#### DEPARTMENT OF TRANSPORTATION

August 30, 2007

#### **MEMORANDUM**

To: All Holders of the Virginia Department of Transportation's 2001 Road and Bridge Standards

REV 8/07 107.01

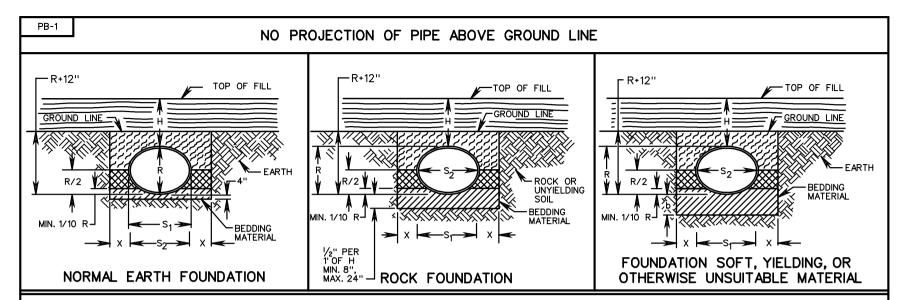
107.02	A-86	PB-1	Revised notes to allow the use of crushed glass in place of aggregate.
107.03	A-120	PB-1	Revised notes to allow the use of crushed glass in place of aggregate.

CRUSHED GLASS CONFORMING TO THE SIZE REQUIREMENTS FOR CRUSHER RUN AGGREGATE SIZE 25 AND 26 MAY BE USED IN PLACE OF CLASS I BACKFILL.

**REV 8/07** 114.03

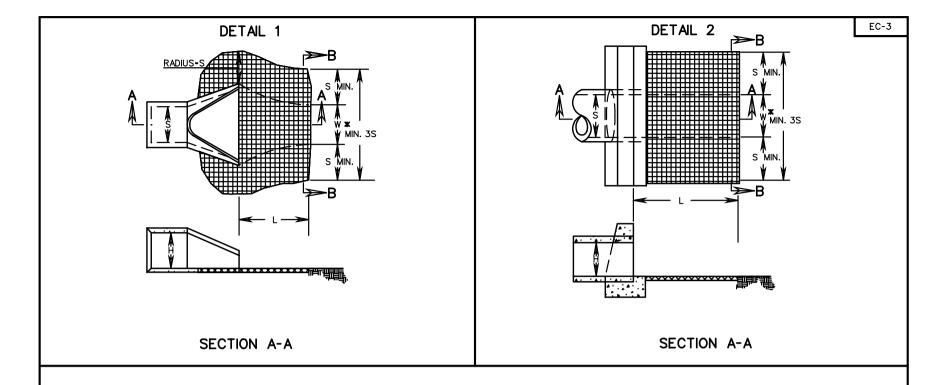
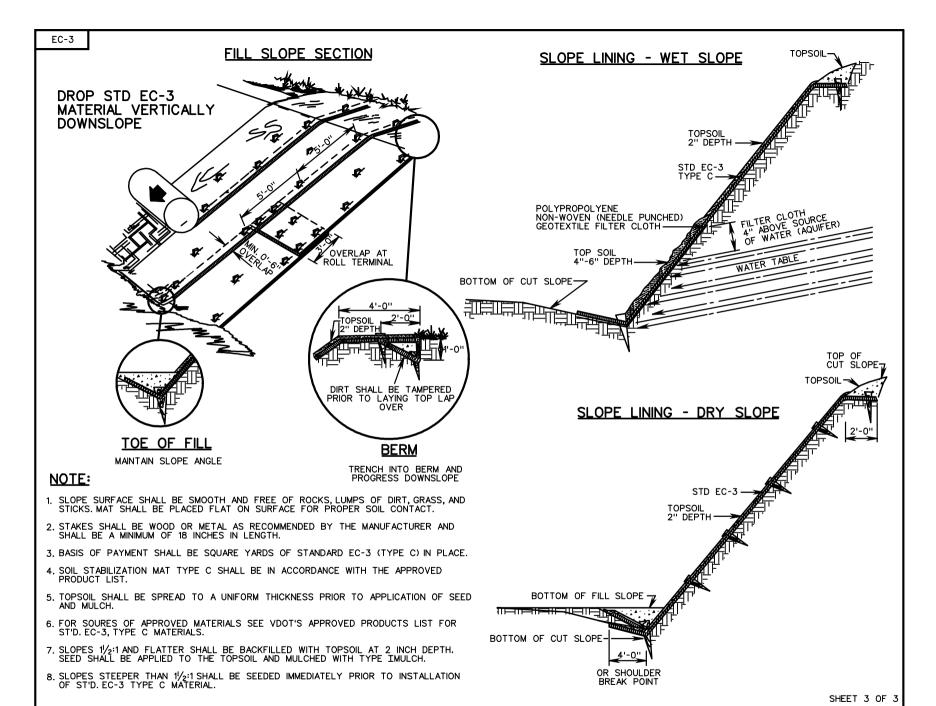
114.03	A-70_1	EC-3	Revised to be EC-3 Sheet 1 of 3.
114.03A	A-70_1	EC-3	Added new EC-3 sheet to match old pay item codes.
114.04	A-70_2	EC-3	Revised to be EC-3 Sheet 3 of 3.

REV 8/07 301.08

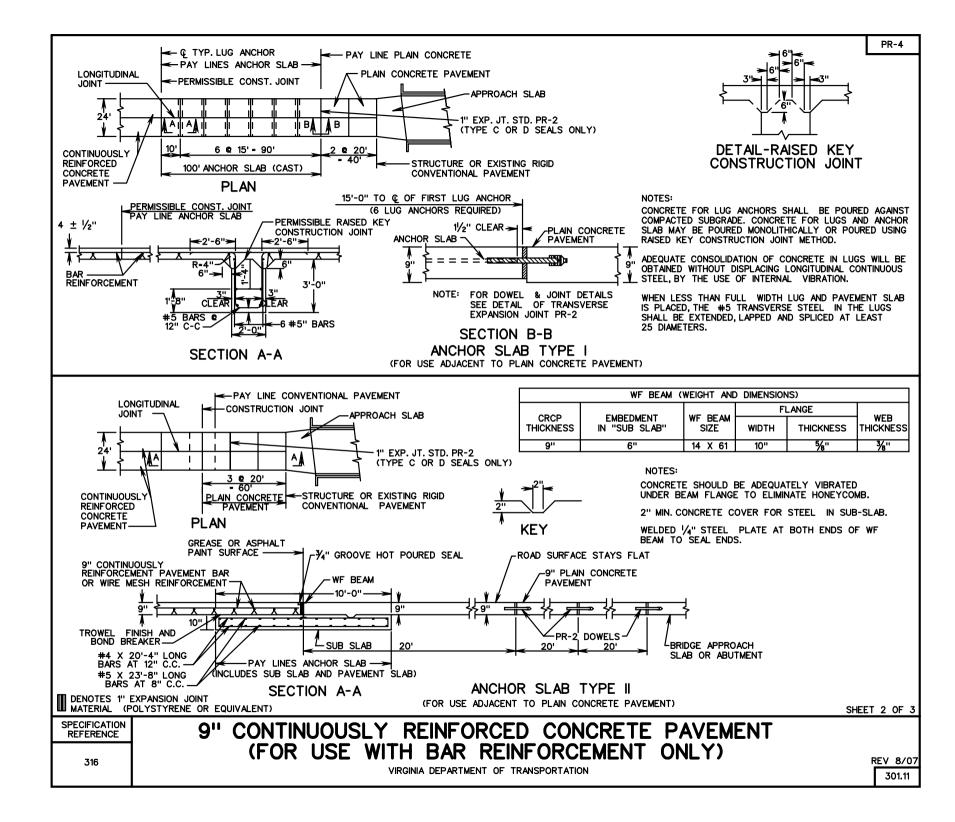
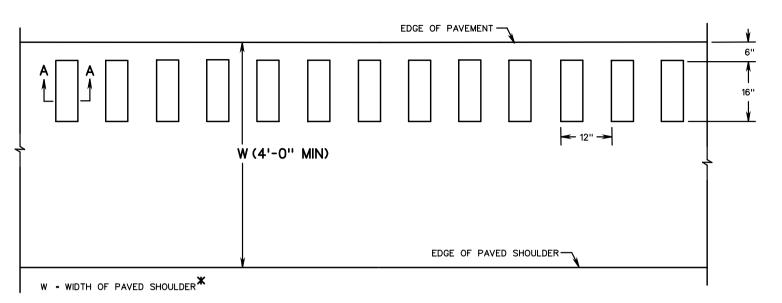
203.04	A-195	CG-11	Revised sheet to clarify differences between street connections and commercial entrances.
301.08	A-193	PR-3	Revised Anchor Slab Type I, Section A-A to include missing rebar across construction joint.
